NUMBER D2-14934-6

TITLE WS-133A Maintainability Program, Final Report

MODEL NO. WS-133A CONTRACT NO. AF04(647)-289

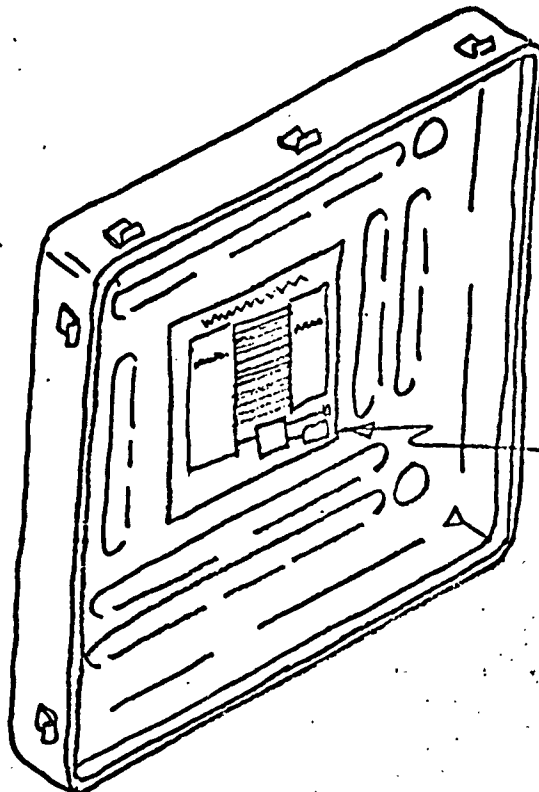
See Item 24.

WEIGHT WITH ALL CABLES - 128 LB

ADD (18TYA)

ADD WEIGHT DESIGNATION TO EACH FLAP

ADD
PLACARD SHOWING
CABLE HOOK-UP
FOR PROGRAMMER
GROUP TEST
SET SELF-TEST
(REF. T.O. 21-SM80A-23)
FIG. 2-25

Item 10

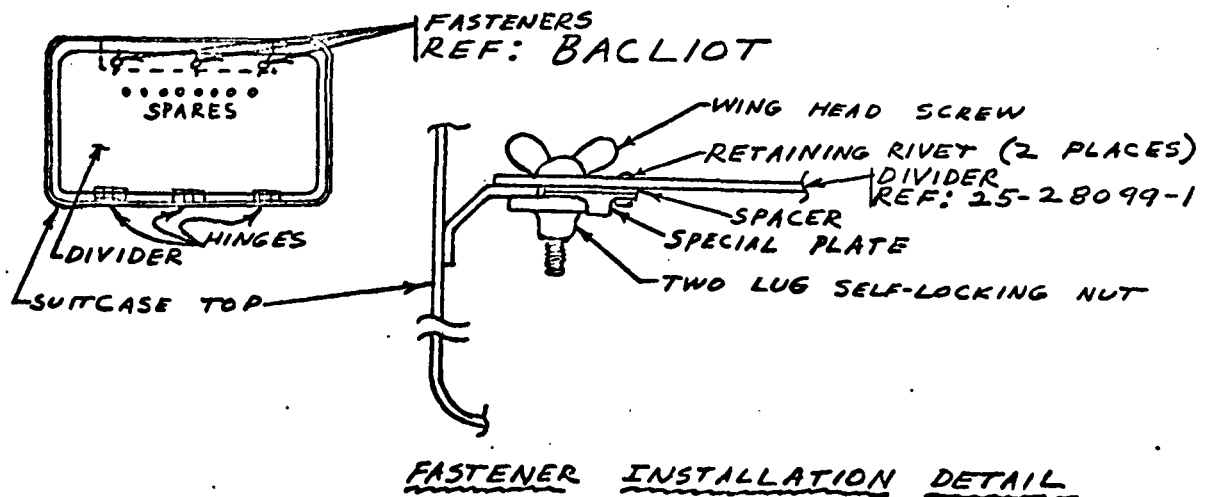
- a. Problem: Some Figure A test equipment has several separate cases. Multiple case units include Figure A's 4490, 4012, 3092, and 3007. Figure A 3007 has 14 separate pieces. The technician has no immediate method to determine the number of individual cases in a Figure A, and which case, if any, is missing.

Recommendation: Mark the individual cases-for example: if the Figure A consists of three cases, label them 1 of 3, 2 of 3, and 3 of 3.
